ENGINEERING CHANGE NOTICE

Proj. ECN B-714-53

Block 5: B-714, GROUT VAULT PAIR (218-E-16-102 & 103)(218-E-16-104 & 105)/EDMC
Block 9: ECN B-714-17, B-714-22, B-714-30, B-714-42
Block 8: **AFFECTED DOCUMENTS (Drawings)**

13a. Justification (mark one)	13b. Justification Details
Criteria Change ■ Design Improvement ■ Environmental ☐ As-Found ☐ Facilitate Const. ■ Const. Error/Omission ☐ Design Error/Omission ■	CRITERIA CHANGE to separate Safety Class 2 & 3 wiring; ITEM #'s 6, 7, 17, 22, 23 & 34 (Ref WHC-SD-B714-W-QAPP-001, REV 4) ALL OTHER ITEMS are miscellaneous design improvements, drawing errors, design clarification and ease of construction changes.

KAISER ENGINEERS HANFORD	ENGINEERING CHANGE NOTICE SKETCH					
Ref. Dwg. H-2-77635	Sh. 2	Rev. 0	Prepared By A.R. SNOWHITE	Checked By	ECN No. B-714-53	Page 29/49

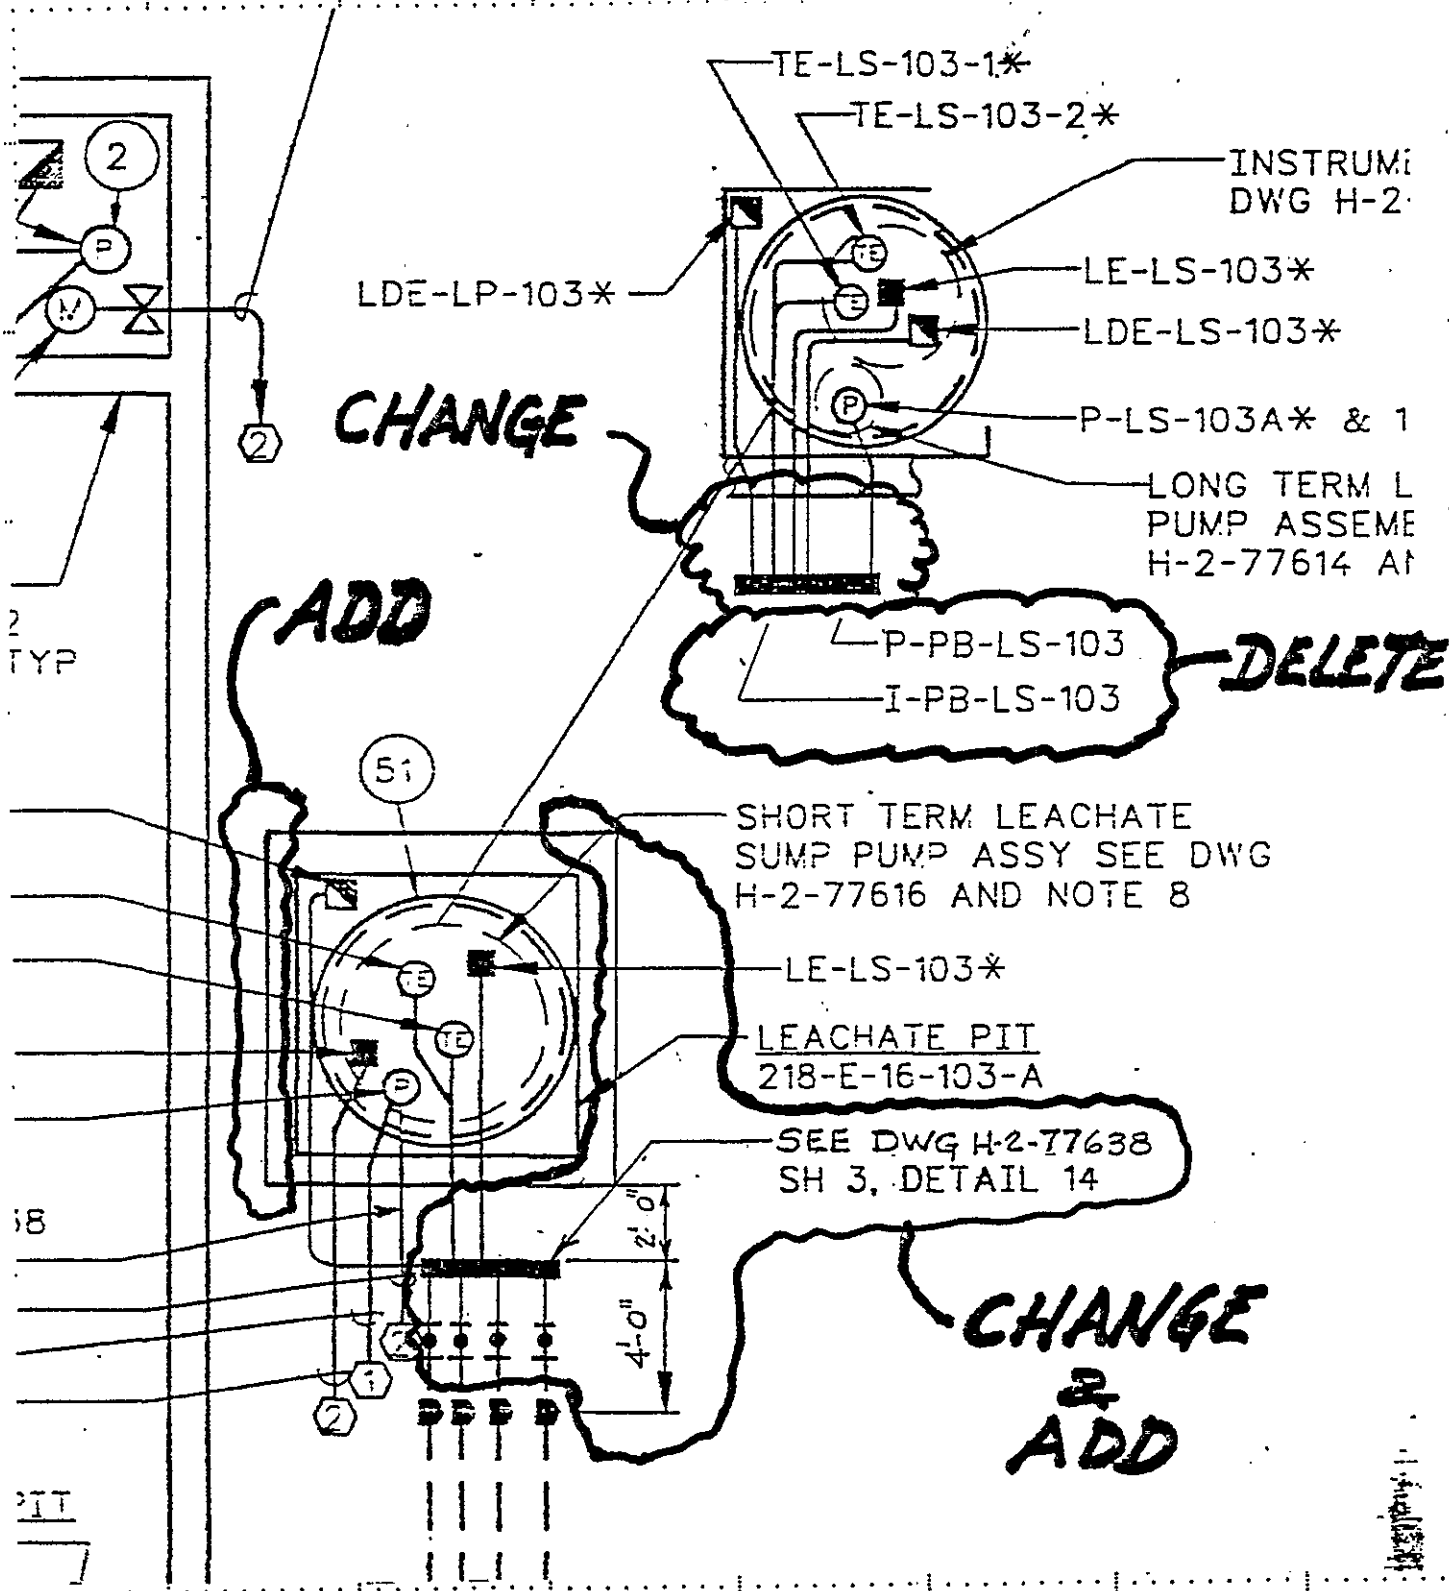
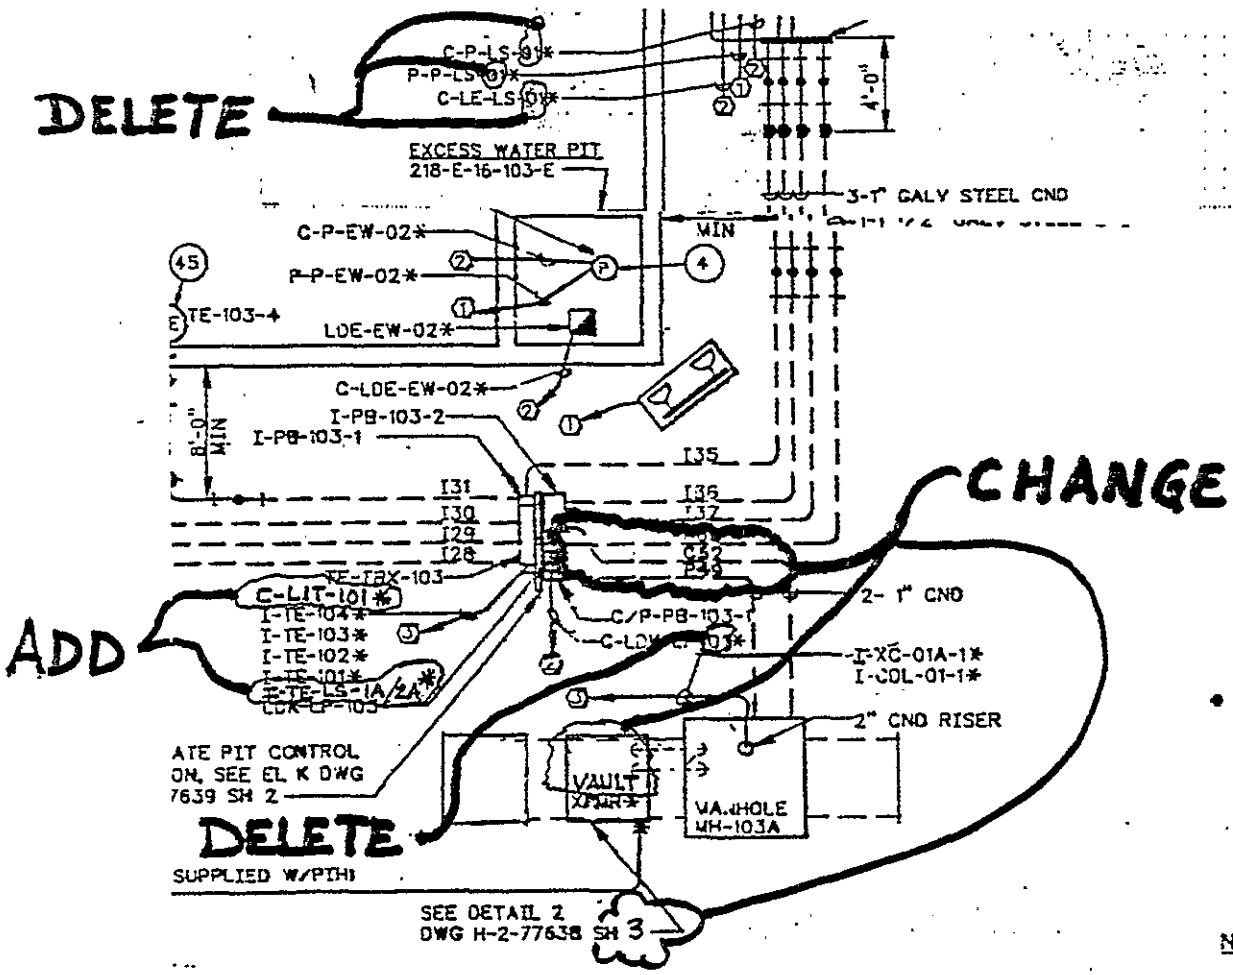
7) H-2-77635, SH 2, REV 0
   PLAN (ZD2-E3, C3): Modify - see page 29 & 30 of this ECN

KAISER ENGINEERS HANFORD	Ref. Dwg. H-2-77636	Sh. 1	Rev. 0	Prepared By TK EHRHARD
ENGINEERING CHANGE NOTICE SKETCH	H-2-77636	3	0	Checked By
				ECN No. B-714-53
				Page 31/49

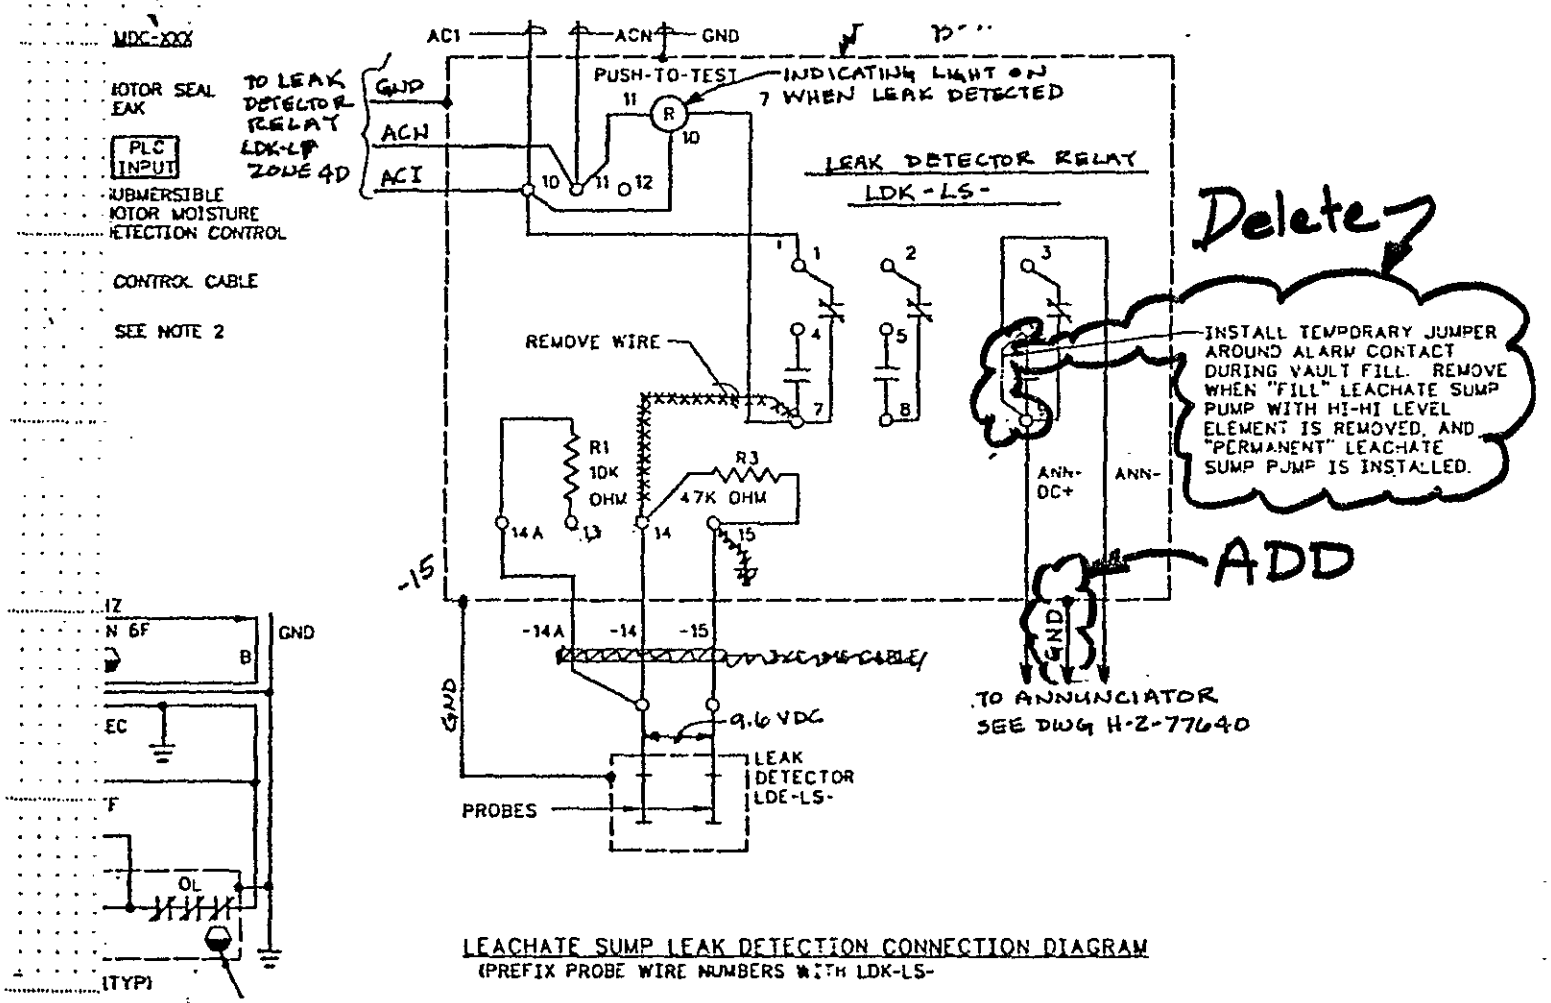
8) H-2-77636, SH 1, REV 0
   A) LONG TERM LEACHATE SUMP PUMPS (ZC5): Delete D-PB-01-13C in its entirety
   B) LEACHATE SUMP LEAK DETECTION CONN DIAG (ZD3, E2-3): Modify - see page 31 of this ECN
   C) SHORT TERM LEACHATE SUMP PUMP, EXCESS WATER PUMPS & EW DIVERTER VALVE MOV-08: Delete elementary diagrams by cross-hatching. In ZD4 ADD the following note leadered to the cross-hatching: SEE DWG H-2-80976 & H-2-80978 FOR WIRING DIAGRAMS

10) H-2-77636, SH 3, REV 0
A) SHORT TERM LEACHATE SUMP PUMP P-LS-01 & EXCESS WATER PUMPS P-EW-01, -02, -03 & -04 (ZD5-F6): Delete by cross-hatching
B) EW DIVERTER VALVE MOV-08 ELEM DIAG (ZA7-F8): Delete by cross-hatching
C) In ZC5 ADD the following note leadered to the cross-hatching: SEE DWG H-2-80976 & H-2-80978 FOR WIRING DIAGRAMS
D) LONG TERM LEACHATE SUMP PUMPS ELEM DIAG (ZC5): Delete D-PB-01-13C in its entirety
E) LEACHATE SUMP LEAK DETECTION CONN DIAG (ZE2-3, D3): Modify - see page 31 of this ECN

KAISER ENGINEERS HANFORD	ENGINEERING CHANGE NOTICE SKETCH					
Ref. Dwg. H-2-77636	Sh. 2	Rev. 0	Prepared By A.R. SNOWHITE	Checked By [illegible]	ECN No. B-714-53	Page 32/49

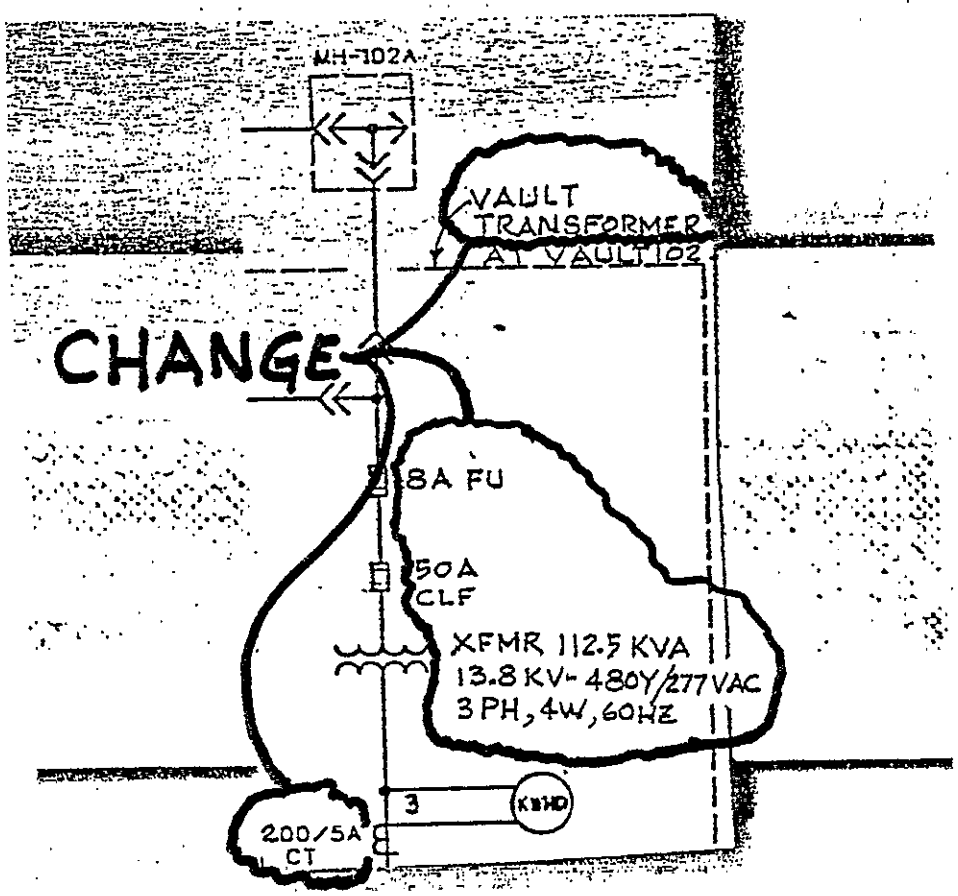
9) H-2-77636, SH 2, REV 0
ONE LINE DIAG (ZD-E7): Modify - see page 32 of this ECN

KAISER ENGINEERS HANFORD	ENGINEERING CHANGE NOTICE SKETCH					
Ref. Dwg. H-2-77638	Sh. 2	Rev. 0	Prepared By A. R. SNOWHITE	Checked By	ECN No. B-714-53	Page 33/49

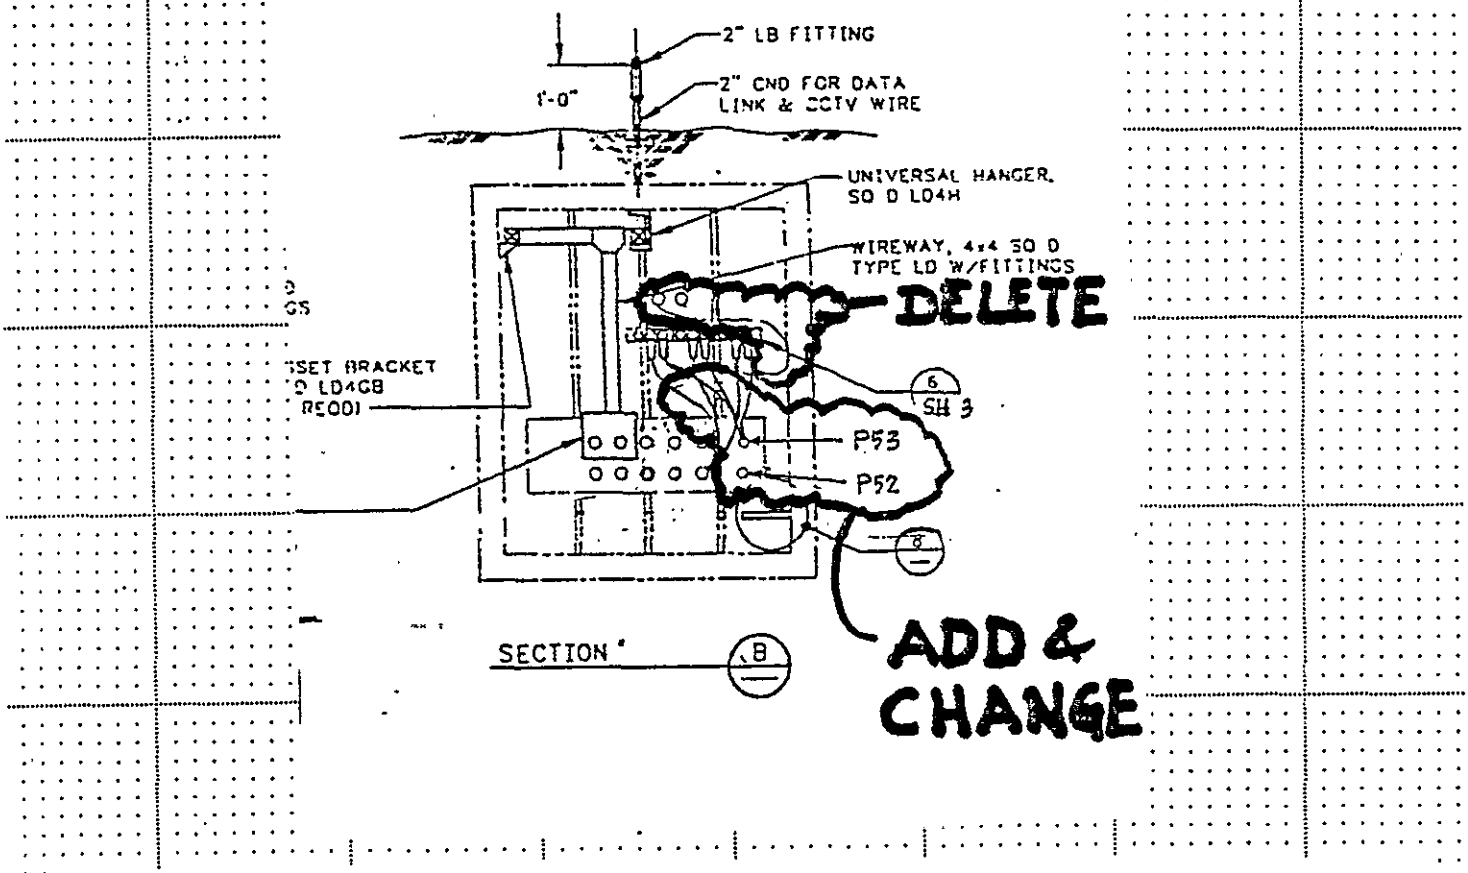
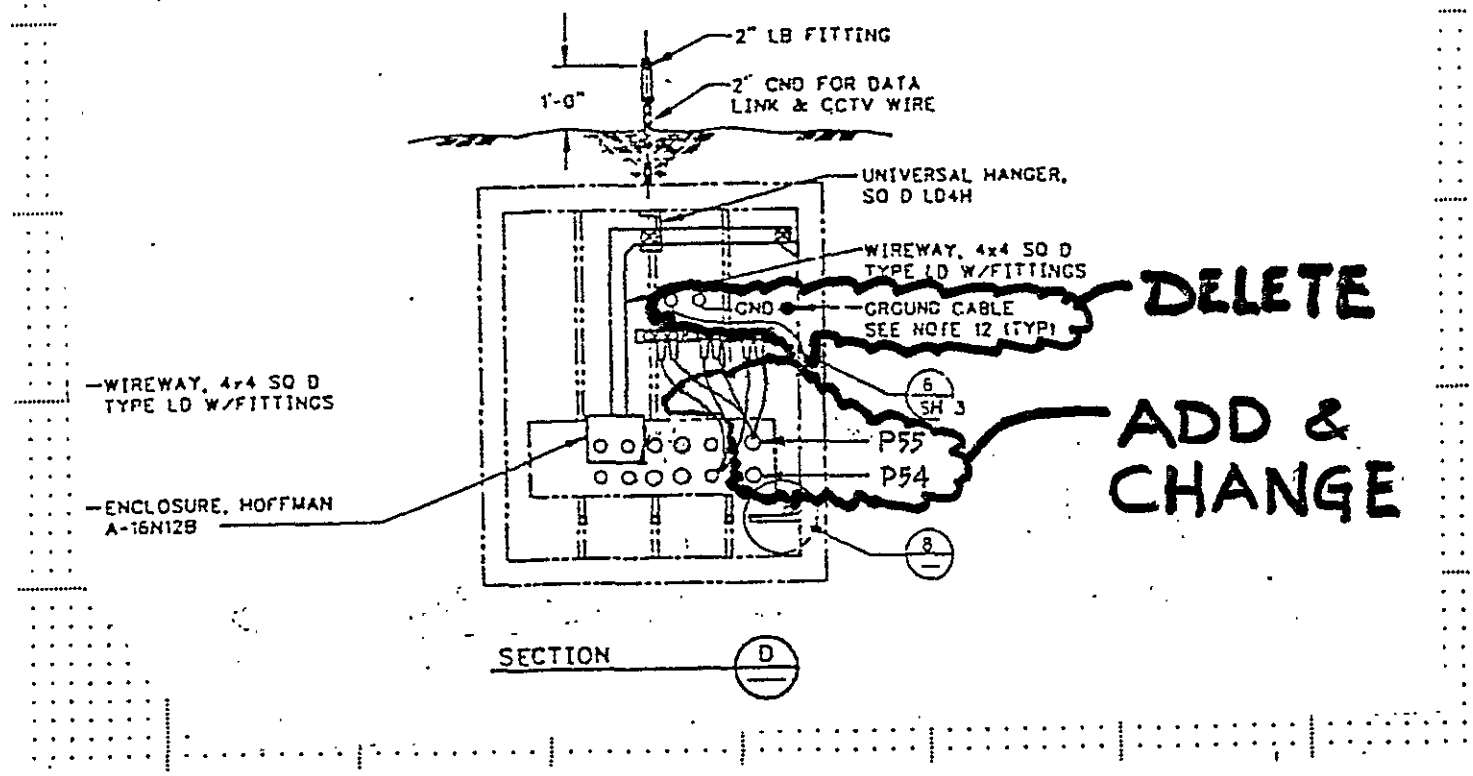
12) H-2-77638, SH 2, REV 0
A) MANHOLE PLAN 102A (ZE3, F4): Delete coordinate
B) MAHHOLE PLAN 103A (ZE1, F2): Delete coordinates
C) SECTION B (ZC6): Modify - see page 33 of this ECN
D) SECTION D (ZC3): Modify - see page 33 of this ECN

KAISER ENGINEERS HANFORD	ENGINEERING CHANGE NOTICE SKETCH					
Ref. Dwg. H-2-77638	Sh. 3	Rev. 0	Prepared By A.R.SNOWHITE	Checked By C Hublett	ECN No. B-714-53	Page 34/49

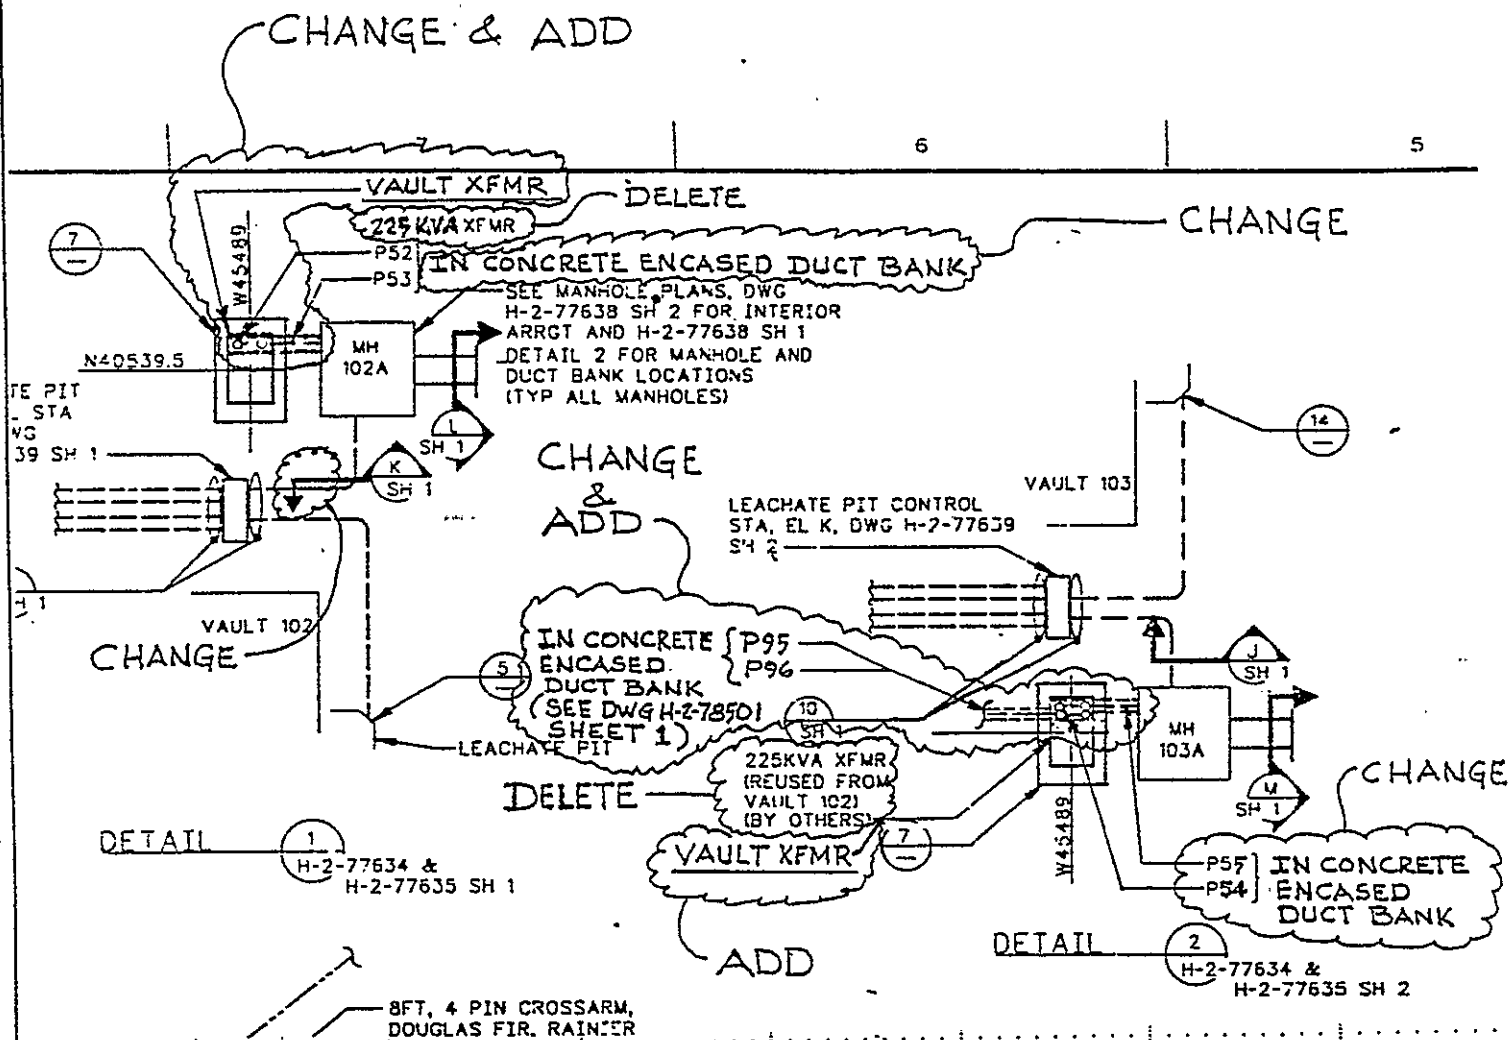
13) H-2-77638, SH 3, REV 0
A) DETAIL 1 (ZF7): Modify - see page 34 of this ECN
B) DETAIL 2 (ZE5-6): Modify - see page 34 of this ECN
